SUBJECT: AN470A4-7 soft rivets

APPLICABILITY: All customers who may have been shipped AN470AD4-7 rivets between 7/25/95 and 10/1/95.

MODEL	ASSEMBLY NAME	REVISION	DATE	VOLUME	PAGE
GLASAIR	SERVICE BULLETIN 142		11/30/95		1 of 1

Figure 1

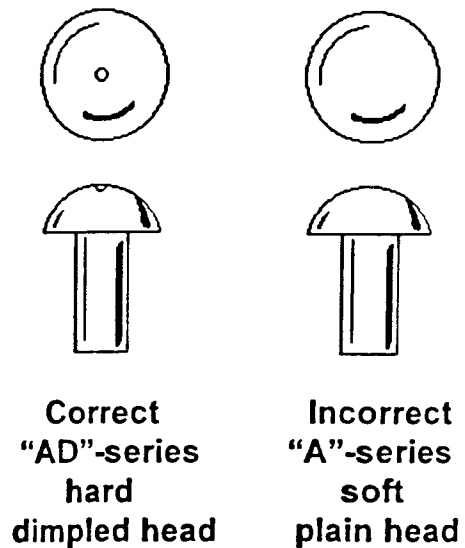
REQUIRED ACTION: First, inspect your supply of AN470AD4-7 rivets and remove all the soft "A" -series rivets. They can be distinguished from the "AD" -series rivets by inspecting the rivet heads. As shown in Figure 1, the standard "AD" -series rivets have a small dimple in the center of the head, while the soft, "A" -series rivets have plain heads.

Second, inspect the Glasair assemblies specified in Table 1 (if you have completed them) to see if any soft, "A"-series rivets were used. If you discover any soft rivets, you must **drill them out and replace them** with proper AN470AD4-7 rivets. If necessary, refer to "FABRICATION TECHNIQUES" in the *Glasair Instruction Manual* to refresh your memory on the proper procedure for replacing defective rivets.
